BEFORE THE ENVIRONMENTAL QUALITY COUNCIL
STATE OF WYOMING

IN THE MATTER OF:)
BASIN ELECTRICAL POWER COOPERATIVE)
DRY FORK STATION,) Docket No. 07-2801
AIR PERMIT CT-4631)

**RESPONDENT DEPARTMENT OF ENVIRONMENTAL QUALITY'S
MEMORANDUM IN SUPPORT OF MOTION FOR PARTIAL SUMMARY
JUDGMENT**

**IN THE MATTER OF A PERMIT APPLICATION (AP-3546) FROM BASIN ELECTRIC
POWER COOPERATIVE TO CONSTRUCT A 385 MW PULVERIZED COAL FIRED
ELECTRIC GENERATING FACILITY TO BE KNOWN AS DRY FORK STATION**

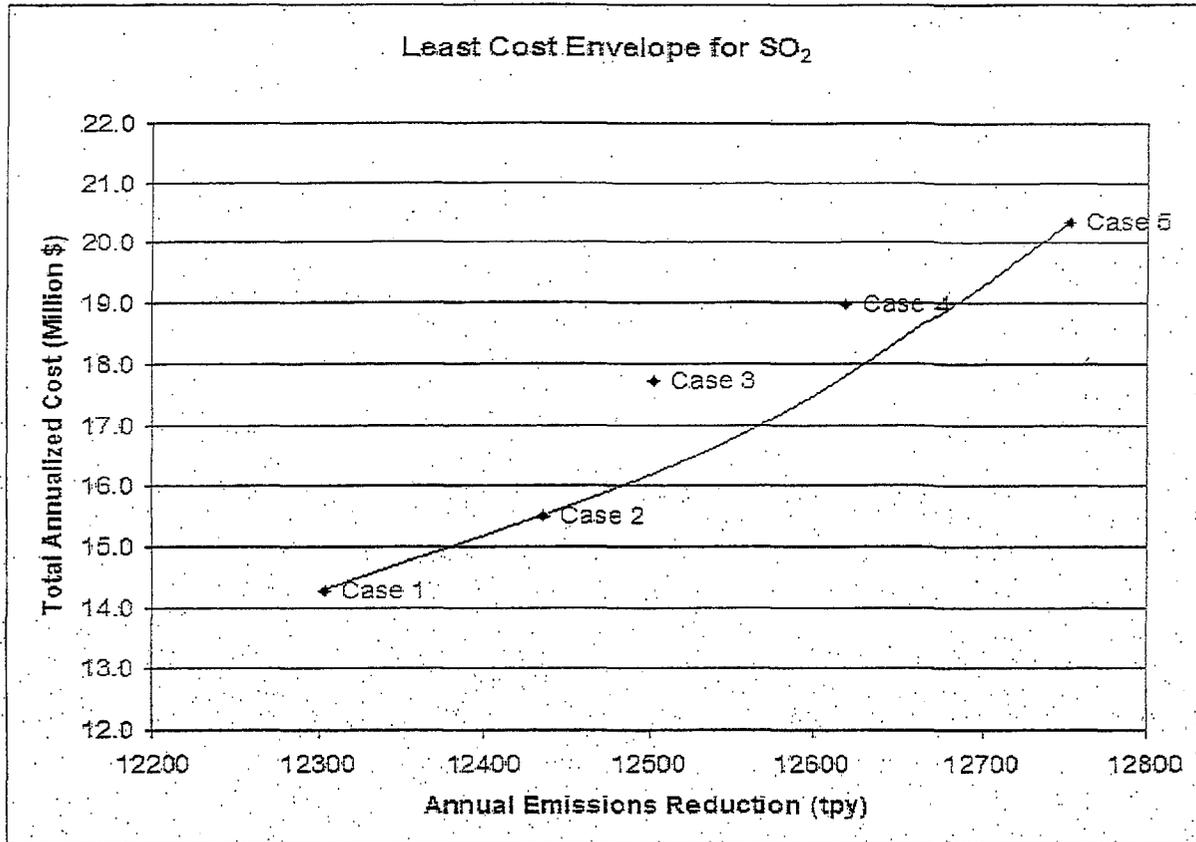
In addition to average cost effectiveness, the draft 1990 New Source Review Workshop Manual provides a method to evaluate incremental cost effectiveness between dominant options known as the least cost envelope. For this method, a plot of annual emissions reduction vs. total annualized cost is produced and the dominant control options are indicated by fitting a curve or line through the lower and right most points as shown below. Points above and to the left of the line are considered inferior controls because points on the line provide more emissions reduction for less money.

The dominant options are Cases 1 (SDA @ 0.081 lb/MMBtu), 2 (SDA @ 0.073 lb/MMBtu), and 5 (Wet FGD @ 0.054 lb/MMBtu). The incremental cost effectiveness for the dominant options is calculated in the following table. The incremental emissions reduction and incremental increase in total annualized cost is the difference in these values for each option from the previous table. The incremental cost effectiveness is the incremental increase in total annualized cost divided by the incremental emissions reduction.
